Proposed North Carolina Amendments to 2023 NEC
Prepared by Electrical Adhoc Committee – April 28, 2023

Figure 410.2 Exception Clothes Closet Storage Space Exception

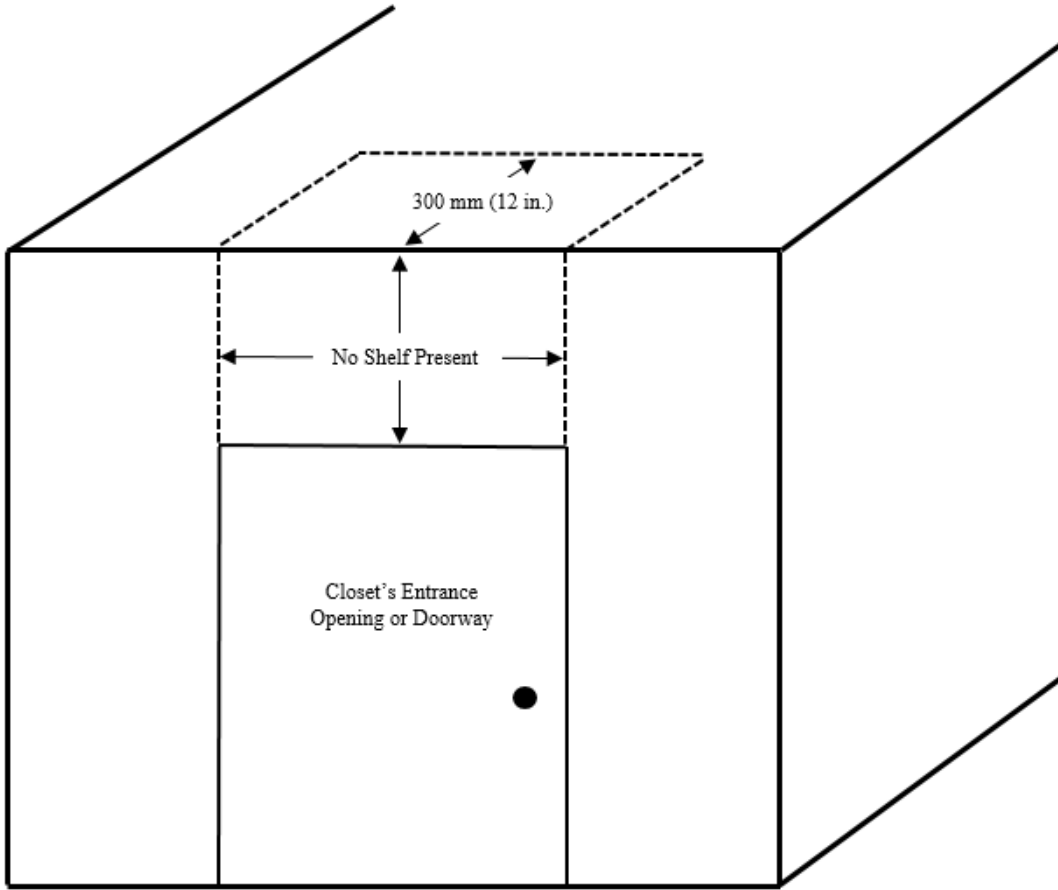
Exception: Where a shelf is not present in the area of wall above the closet's entrance opening or doorway extending from the top of such opening or doorway vertically to the ceiling, including the area of ceiling extending perpendicular from the area of wall directly above the closet's entrance opening or doorway to a horizontal distance of 300 mm (12 in.), shall not be defined as closet storage space. See Figure 410.2 Exception.
